Battery Cable, Routing
 VN, VHD, VAH

FSB 371-049 Battery Cable, Routing

(October 2014)

W3092940

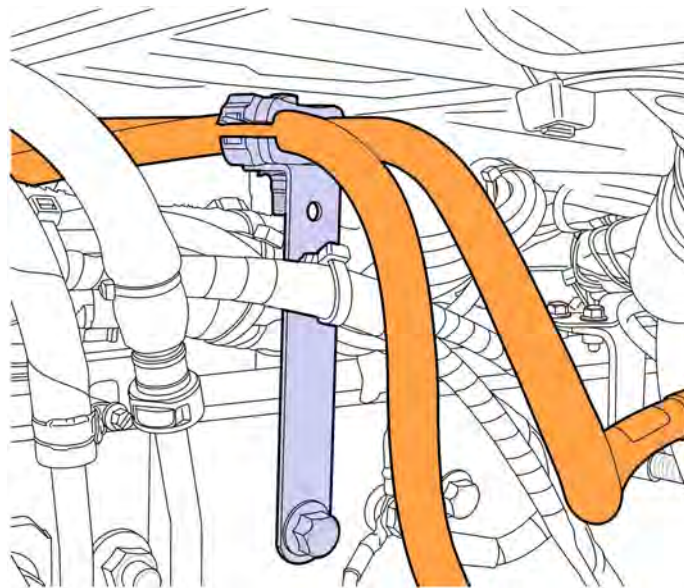
- 1 Locate the positive and negative battery cables above the frame rail and behind the disconnect switch.

Note: Check the battery cables protective coating for heavy chaffing, cuts, excessive wear, exposed and oxidized copper wires. If any these conditions are present, replace cables as required.

Note: If the conditions listed above are not present, a double headed cable tie is still required to prevent battery cable chafing. Go to step 2.

W3092939

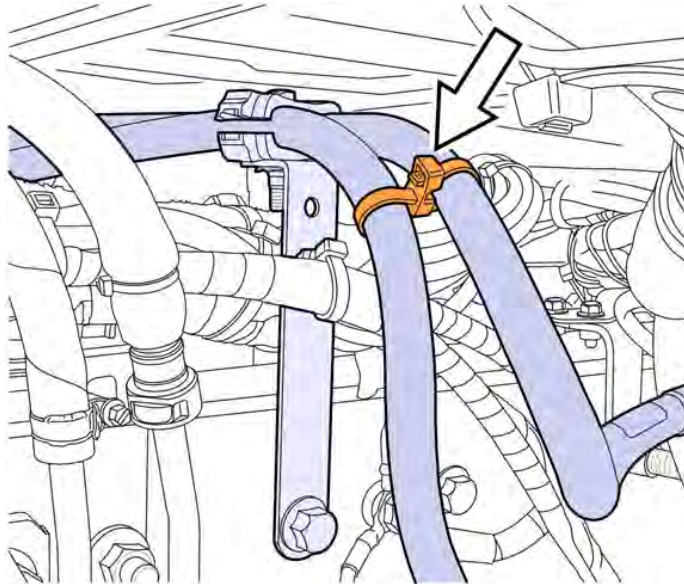
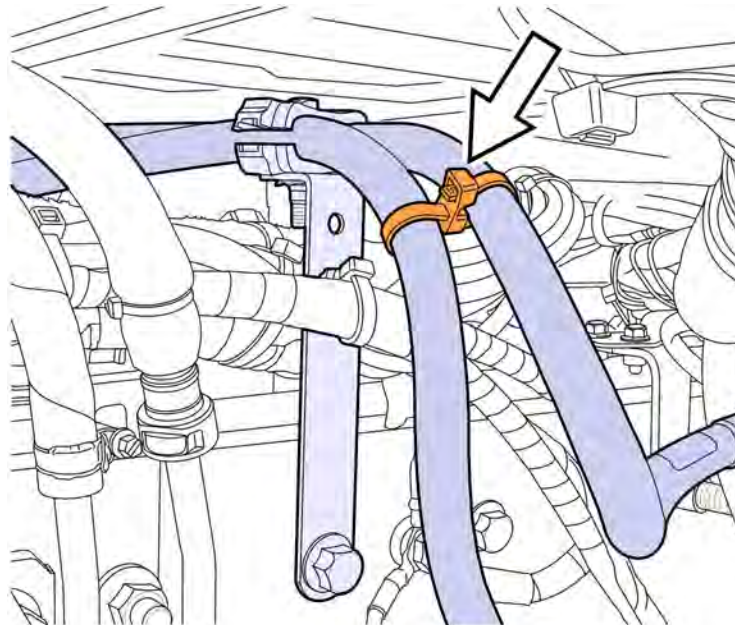
- 2 Install a double headed cable tie in the area as shown in the figure below.

Note: In some cases, a second double headed cable tie may be required to ensure separation of the positive and negative battery cables.
